Roberts Bank Terminal 2 Project

Environment and Climate Change Canada (ECCC) Response to the Proponent's Public Comment Period Submissions

Figure 3: Trends in Western Sandpiper counts conducted at Roberts Bank between 1991 and 2019

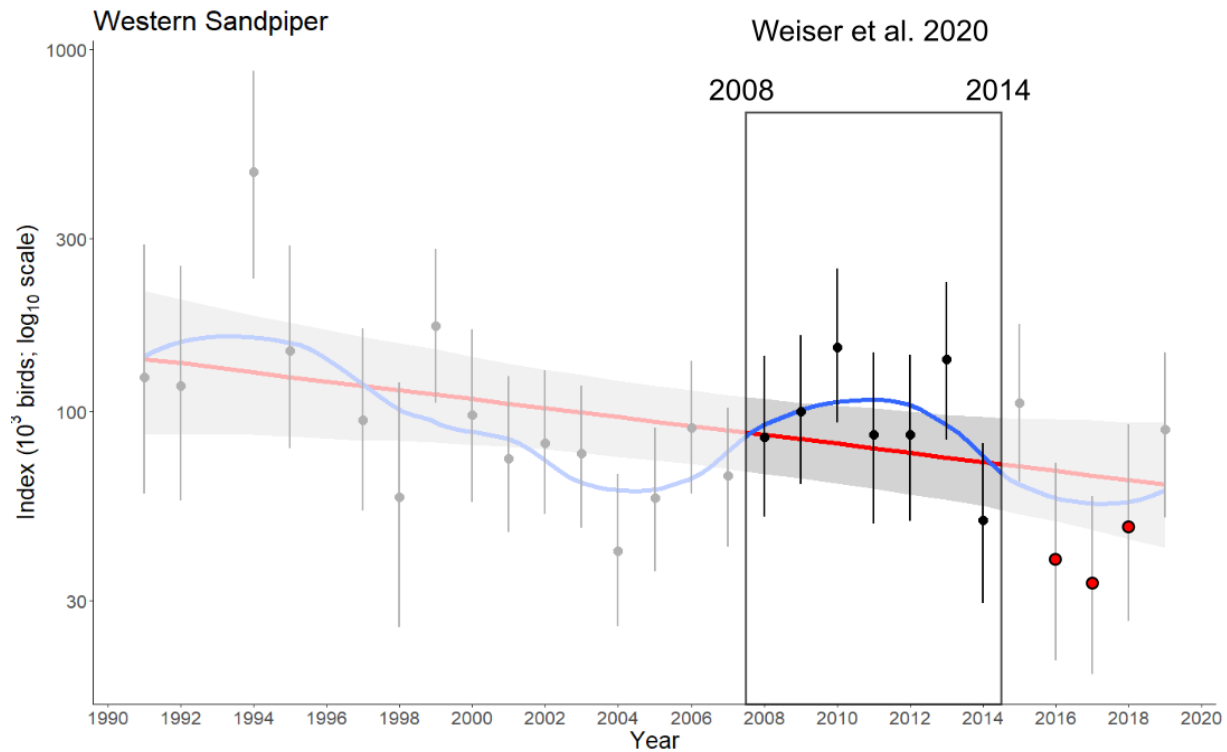
Short-term population fluctuations are often seen in long-term datasets (Figure 3). They can be driven by inter-annual variability in environmental conditions and predator-prey dynamics, and underscore the importance of long-term studies such as Canham *et al.* (2021).

Canham *et al.* (2021) also observed that the abundance of Western Sandpipers is negatively correlated with freshwater discharge from the Fraser River, the main driver of salinity at Roberts Bank. ECCC remains of the opinion that this correlation establishes a clear link between Western Sandpipers and salinity conditions at Roberts Bank, and indicates that changes to the hydrological regime arising from the Project would result in a lower abundance of sandpipers and exacerbate their ongoing long-term population decline.
